RESPONSE TO COUNCIL INFORMATION REQUEST IN RELATION TO THE REEF MARINA REDEVELOPMENT – COMBINED APPLICATION

The following response is provided to Council's Information Request (IR) issued by correspondence dated 30 November, 2016.

APPENDIX: 15

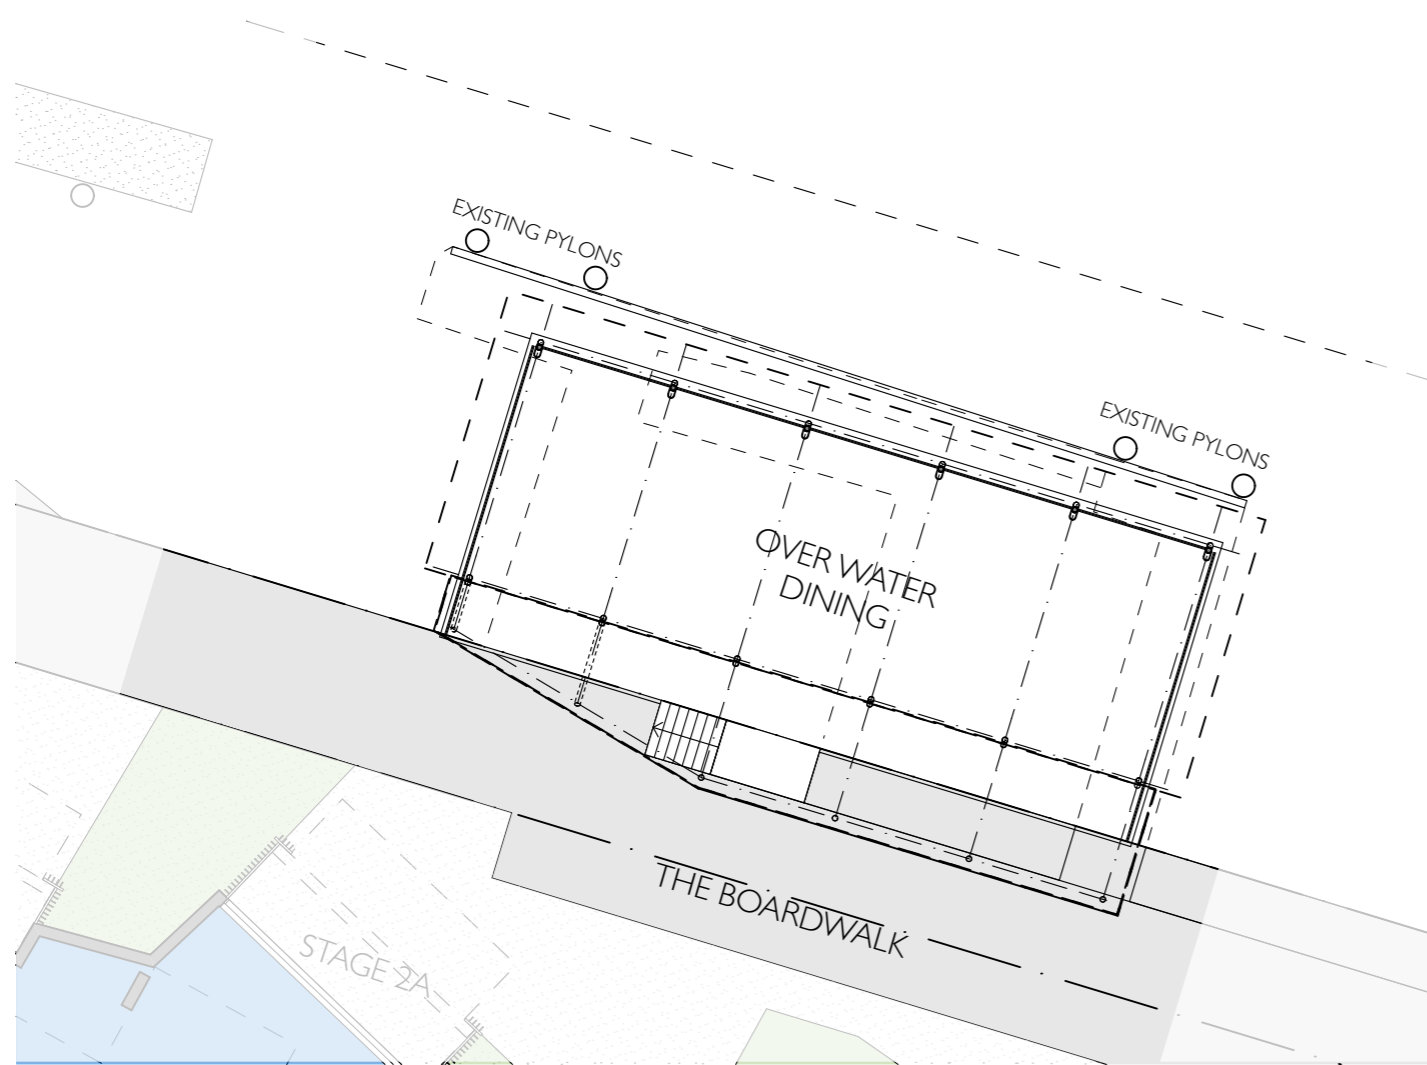
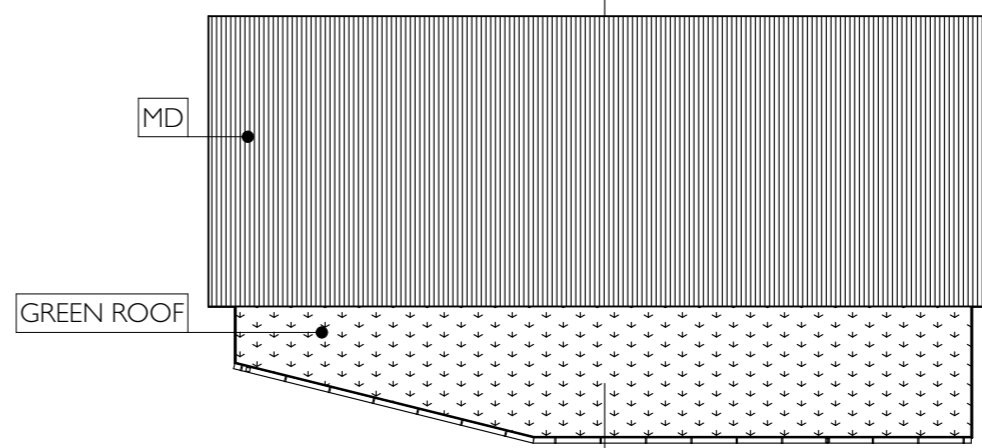
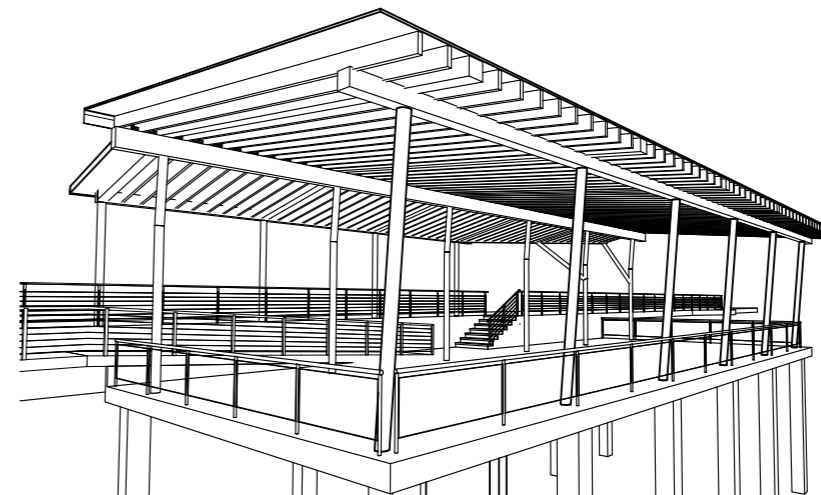
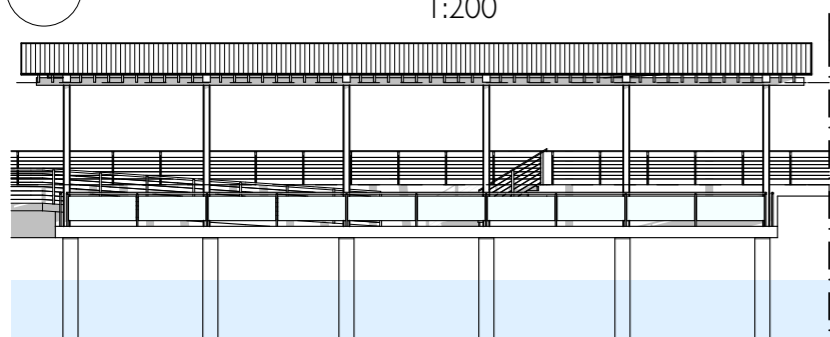
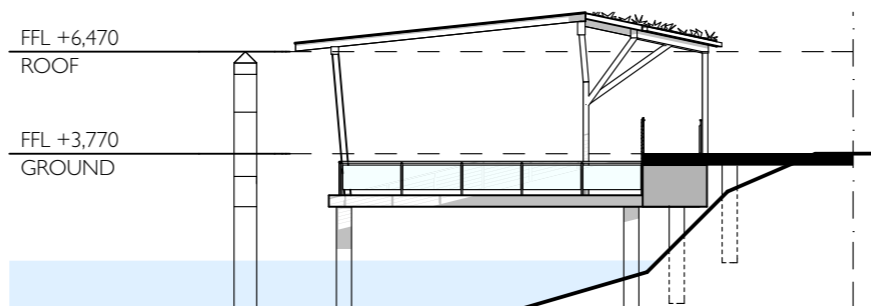
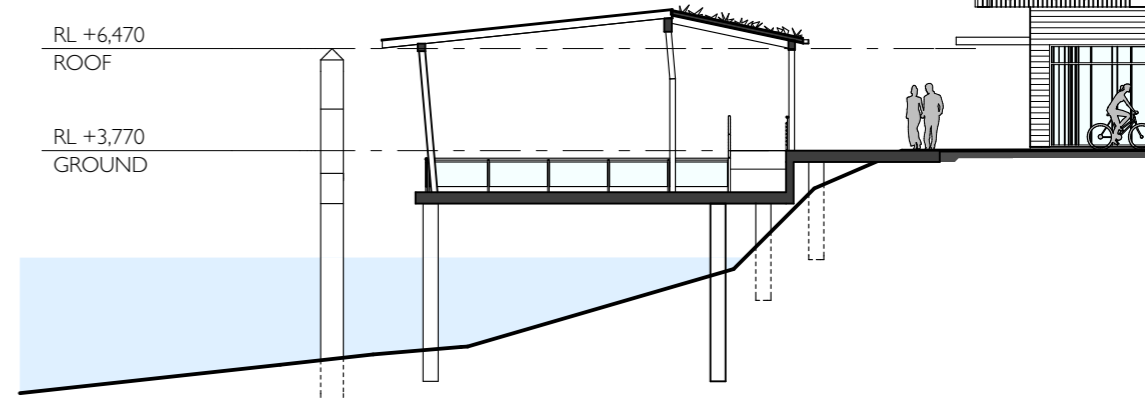
39. Provide details of the proposed over- water dining covered area adjacent to Stage 2A.

Refer to drawing DA-IR-108 OVER- WATER PAVILION at **Appendix 15**, for details.

The colour scheme for the structure will be:

Roof: Colorbond Basalt (under "living' green roof).
Roof: Danpalon polycarbonate roof system –
